1973 Corvette: Service Bulletin: Exhaust Manifold Heat Shielding

73-T-8

Subject: EXHAUST MANIFOLD HEAT SHIELD -
 1973 CORVETTE WITH 350 CU. IN.
 ENGINE WITH AIR CONDITIONING

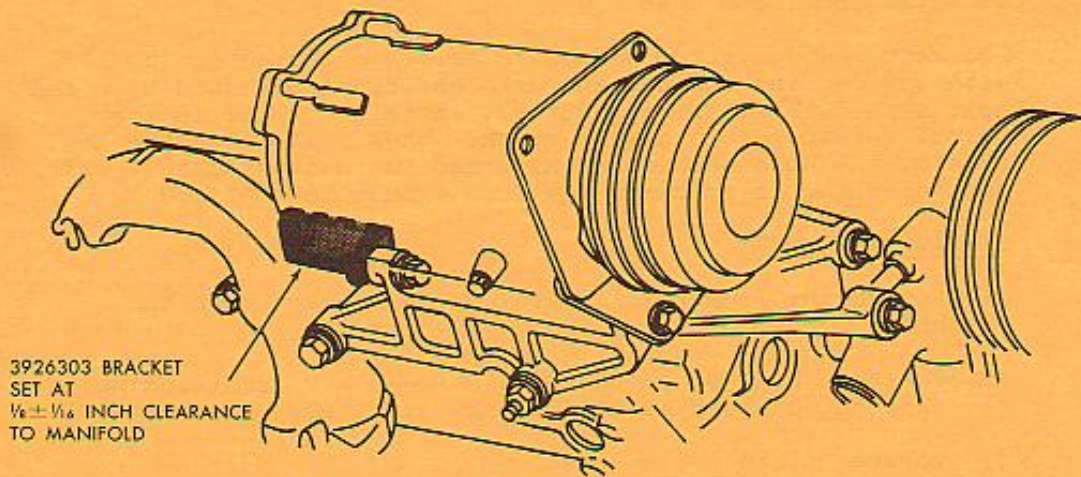
Some early production 1973 Corvettes equipped with 350 cu. in. engines and air conditioning may experience air conditioning hose damage due to close proximity of the exhaust manifold.

Corvettes assembled after September 13, 1972, have a heat shield installed between the hose and the manifold to protect the hose from heat.

For service, Corvettes assembled prior to September 13, 1972, with 350 cu. in. engines and air conditioning should have the heat shield, Part Number 3926303, installed while in for normal service or in dealer stock. When installing the heat shield, the hose should be inspected for heat cracking. If heat cracking is evident, the hose should be replaced.

- 1) Remove nut from rear compressor to bracket mounting bolt.
- 2) Position bracket on bolt and between air conditioning suction hose and manifold as illustrated.
- 3) Torque nut to 25 ft. lbs.
